L-PI-05-074

Prairie Island Nuclear Generating Plant Units 1 and 2
Dockets 50-282 and 50-306
License Nos. DPR-42 and DPR-60

Response to Request for Additional Information Regarding the "Unit 1 Inservice Inspection Summary Report, Interval 3, Period 3, Refueling Outage Dates: 9-10-2004 to 11-23-2004 Fuel Cycle 22: 12-7-2002 to 11-23-2004"

Response to Request for Additional Information Regarding the "Unit 1 Inservice Inspection Summary Report, Interval 3, Period 3, Refueling Outage Dates: 9-10-2004 to 11-23-2004 Fuel Cycle 22: 12-7-2002 to 11-23-2004"

Figure 1: Tubesheet Map

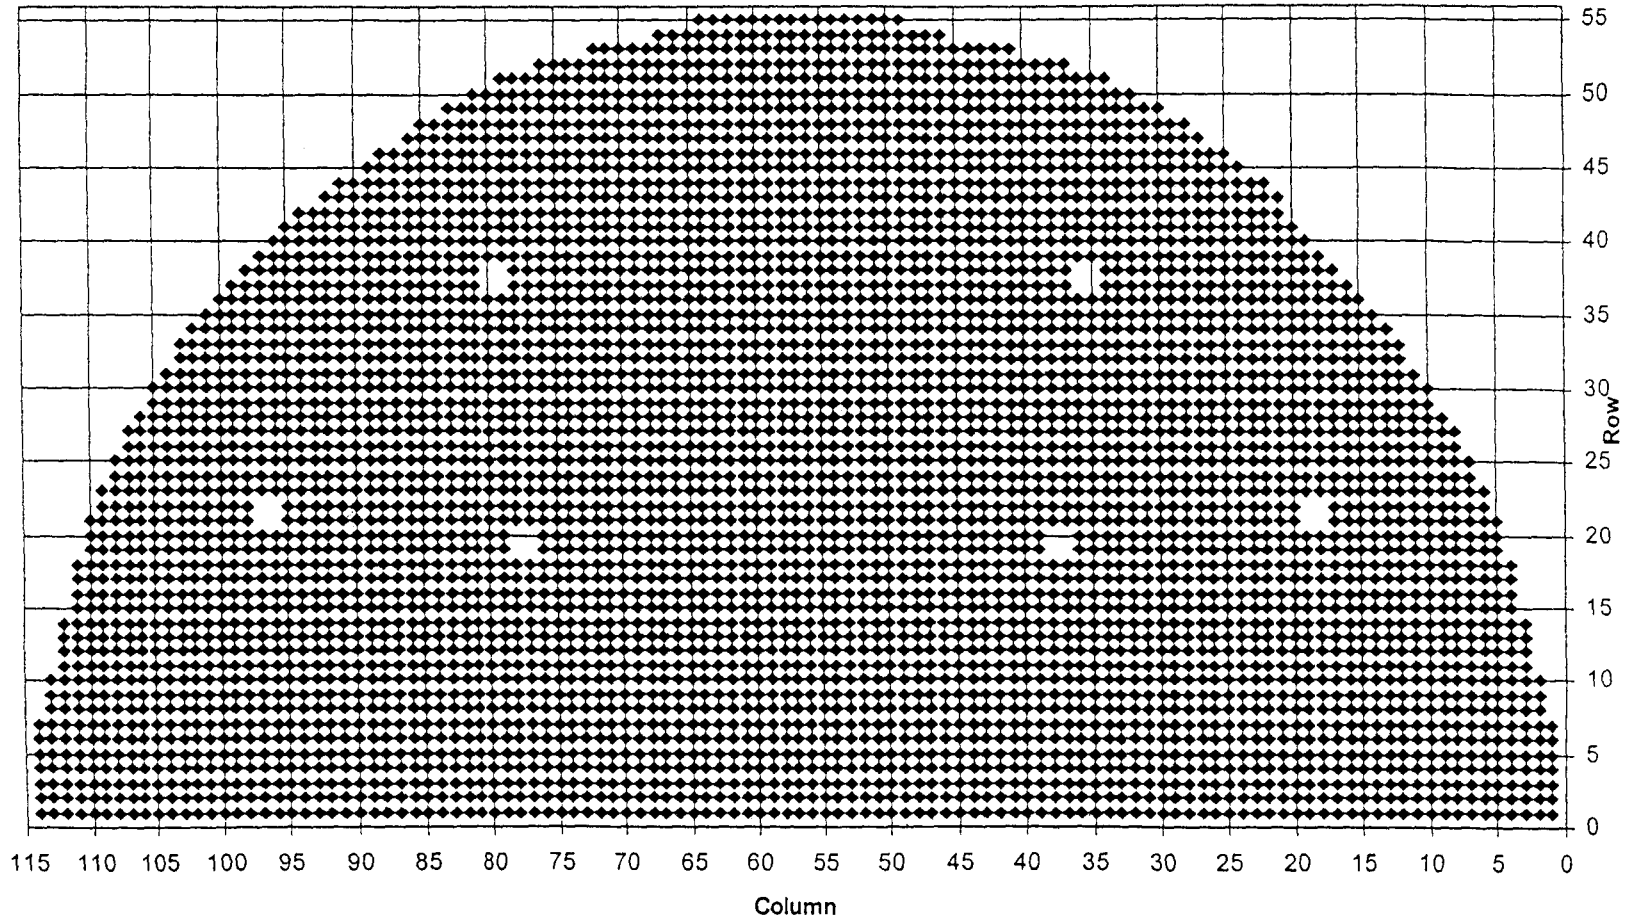
1. **General information concerning the design of your replacement steam generators was provided in the submittal. In order for the staff to better understand the design of your replacement steam generators, please provide the following information: (a) anti-vibration bar design (e.g., rectangular cross-section, penetrate to row 1, thickness, etc.), (b) number of tubes plugged (if any) in each steam generator prior to installation, (c) tubesheet thickness (with and without clad), (d) tubesheet map, and (e) a sketch of the steam generator depicting your tube support plate naming convention. Please (f) clarify whether any tubes (or portions of tubes) were stress relieved after bending. In addition, (g) please clarify if the first tube support plate is a flow distribution baffle (and, if so, any unique design features).**

- (b) *There were 0 (zero) tubes plugged prior to and during the installation of the replacement steam generators.*
- (c) *The tubesheet minimum thickness without the clad is 21.46 inches. The clad has a minimum of 0.375 inch thickness.*
- (d) *See Figure 1 for the tubesheet map. The 6 no-tube areas are the locations of the tube support plate tie-rods (12 total).*
- (e) *See Figure 2 for the sketch of the steam generator showing the tube support plates. The eight stainless steel tube support plates are designated by number and letter (for cold or hot leg side) from the tubesheet upward.*
